TECHNICAL SERVICE BULLETIN

7.3L - Illuminated MIL With Misfire Or Lack Of Power And DTCs P0300, P0316, And/Or P0301-P0304 - Built On Or Before 28-Sep-2020

20-2370

Ford 2020 F-53 Motorhome Chassis	Engine: 7.3L
--	--------------

Figure 1

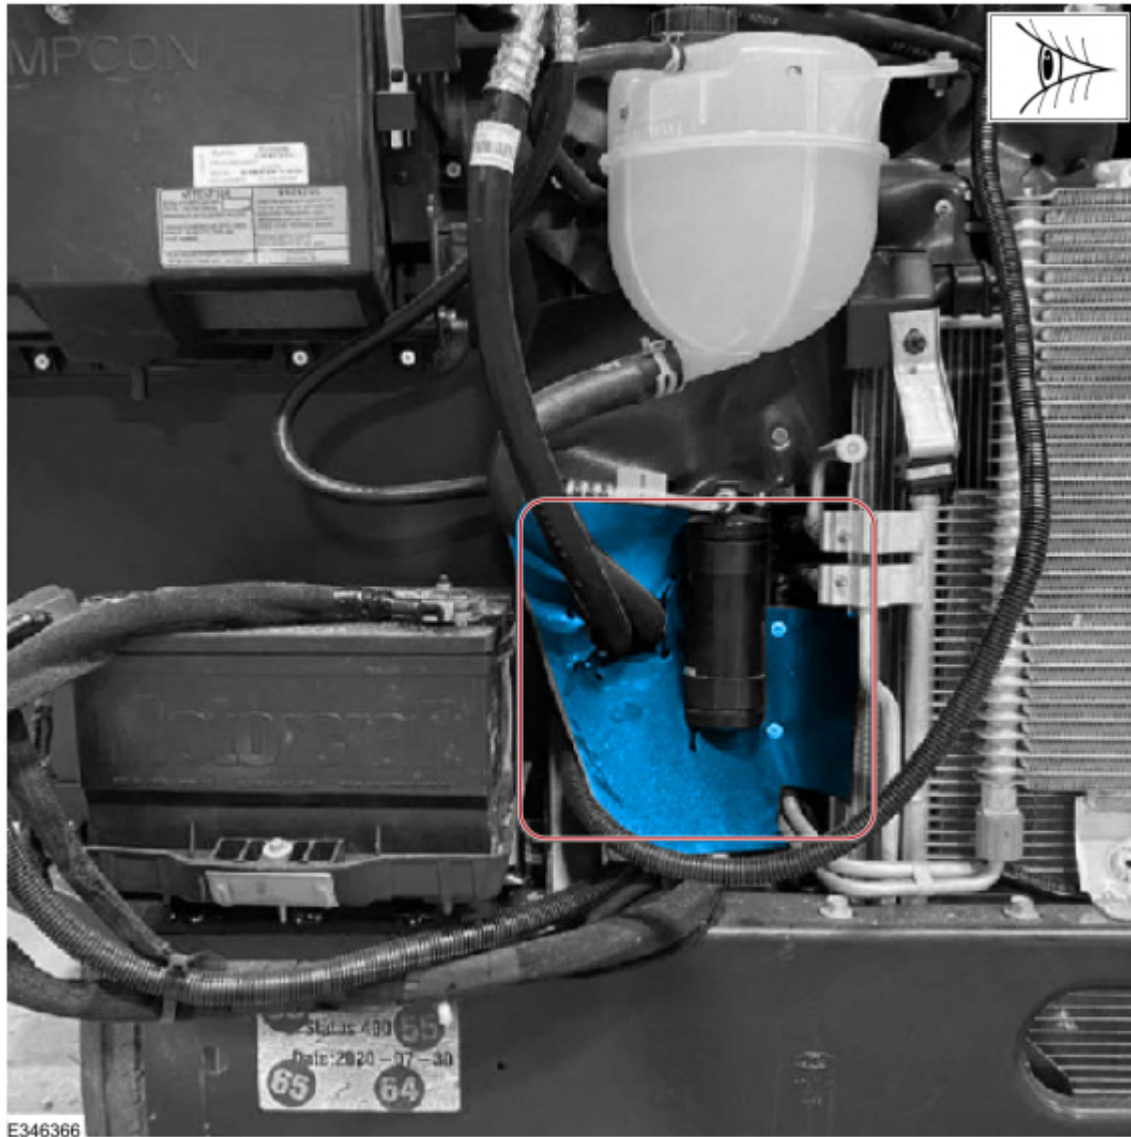
1. Locate the passenger side engine compartment baffle. Does the baffle completely cover the area between the radiator assembly and the battery try as shown in Figure 1?

(1). Yes - proceed to Step 2.

(2). No - this article does not apply. Refer to the Powertrain Control Emission Diagnosis Manual (PC/ED) for normal diagnosis.

Figure 2

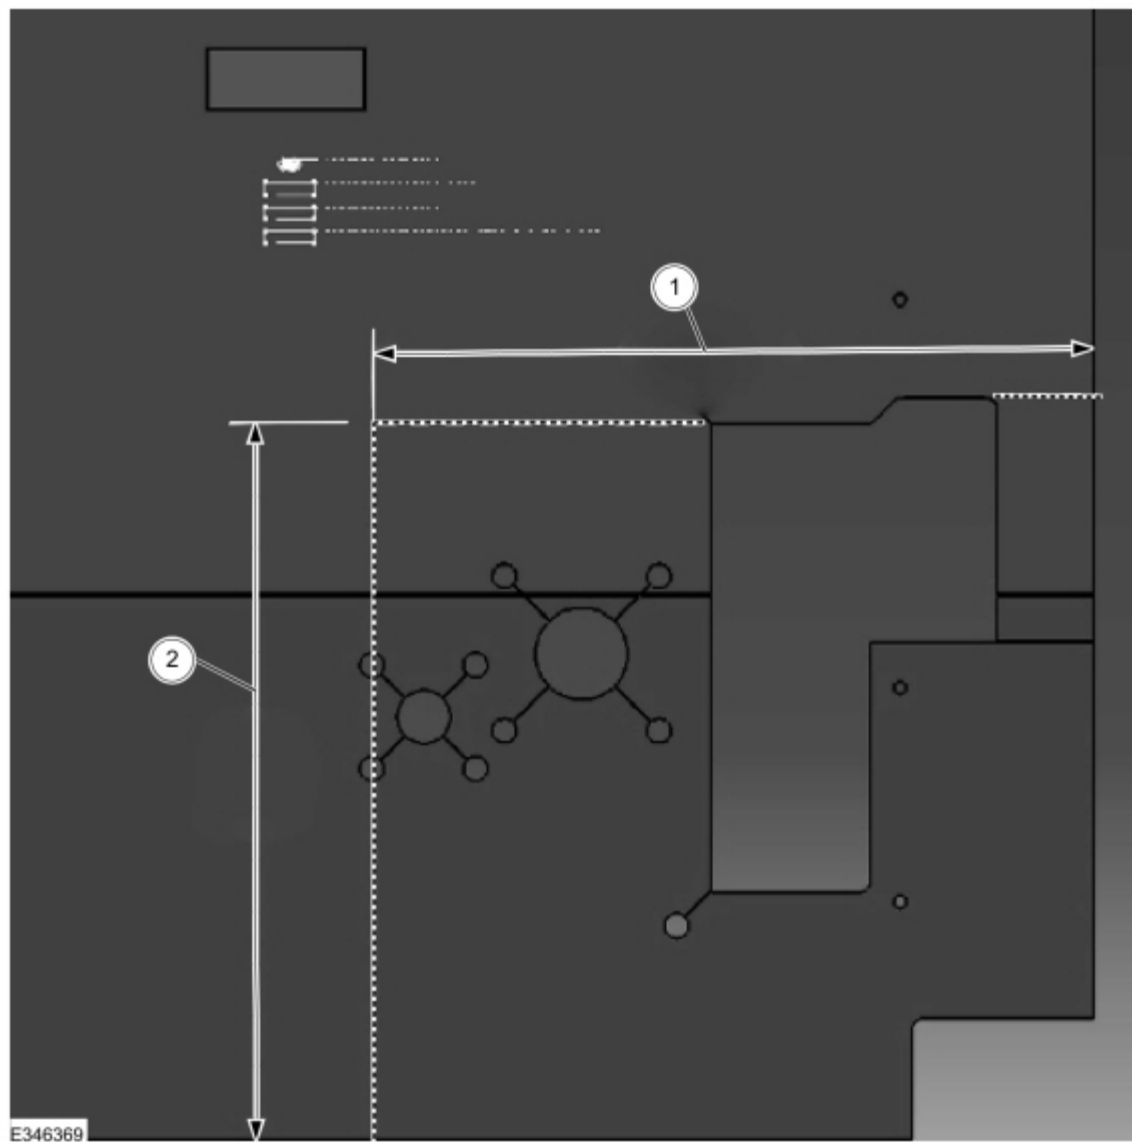
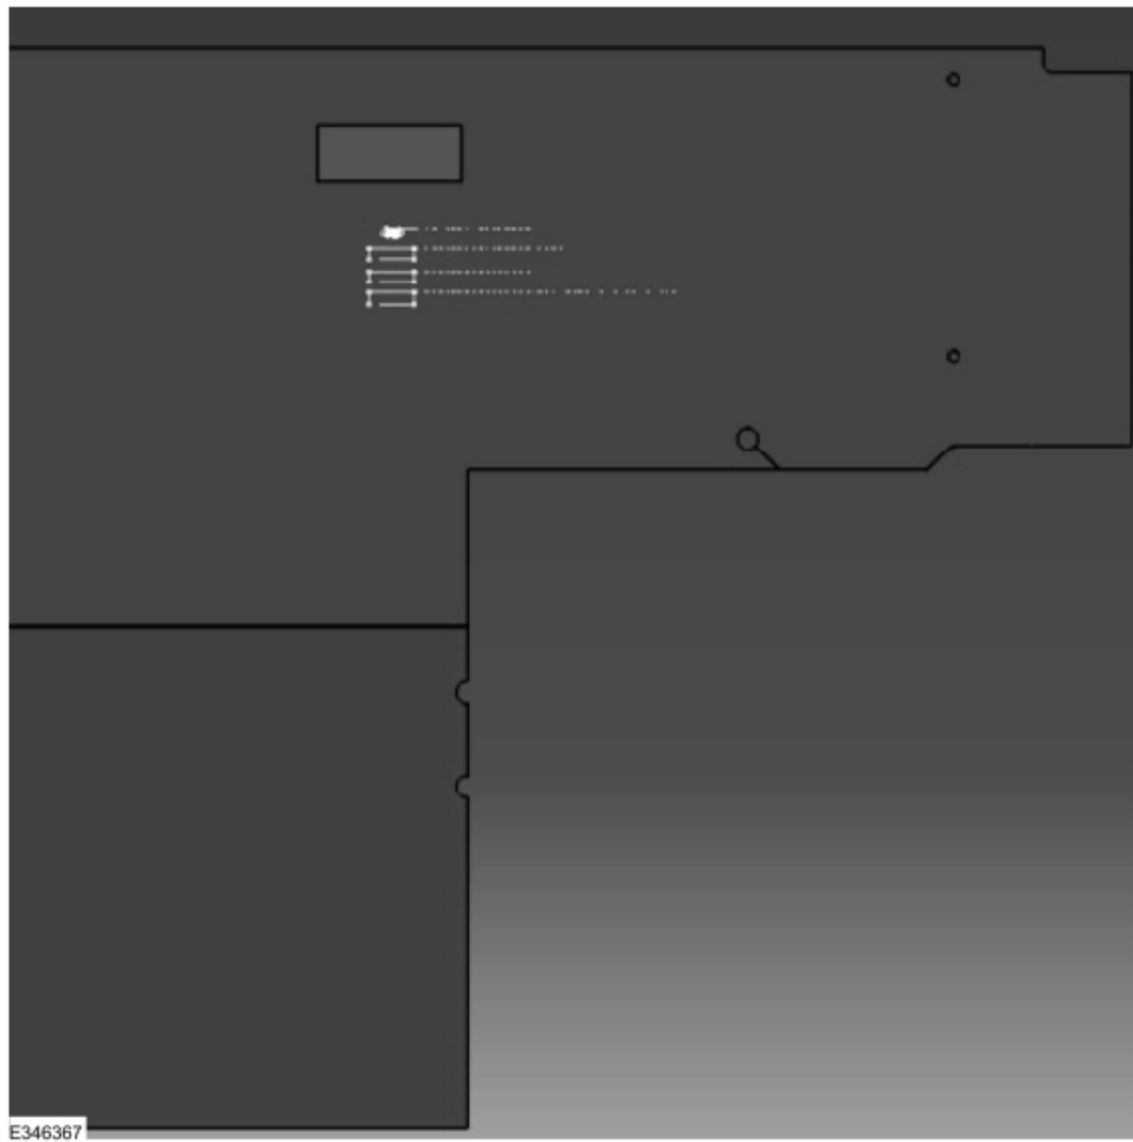
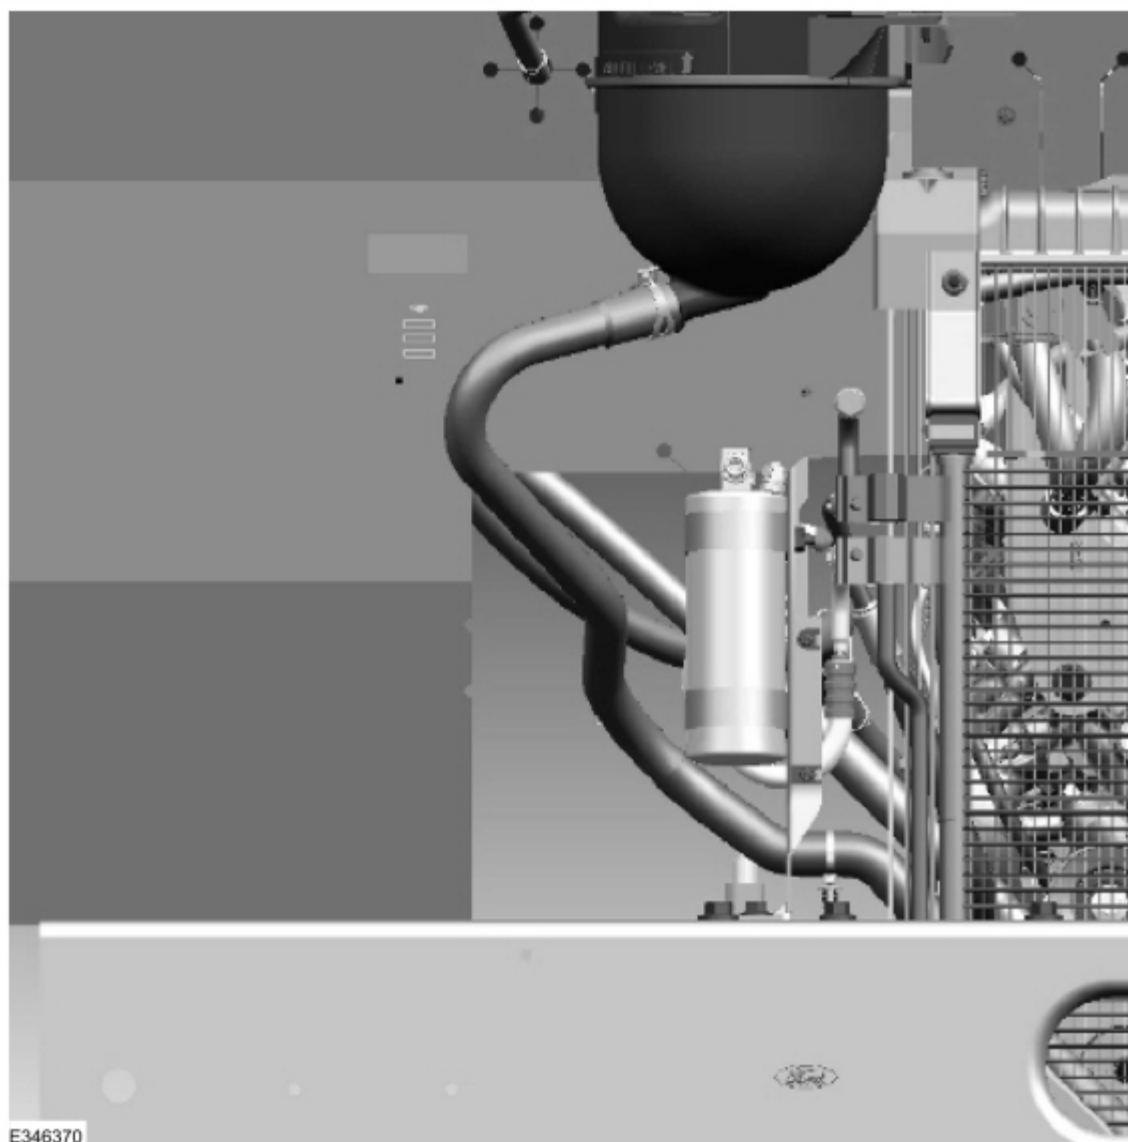
2. Trim the engine cooling baffle on the passenger side using a suitable cutting tool. (Figures 2-4)

Item	Description
1	297 mm
2	295 mm
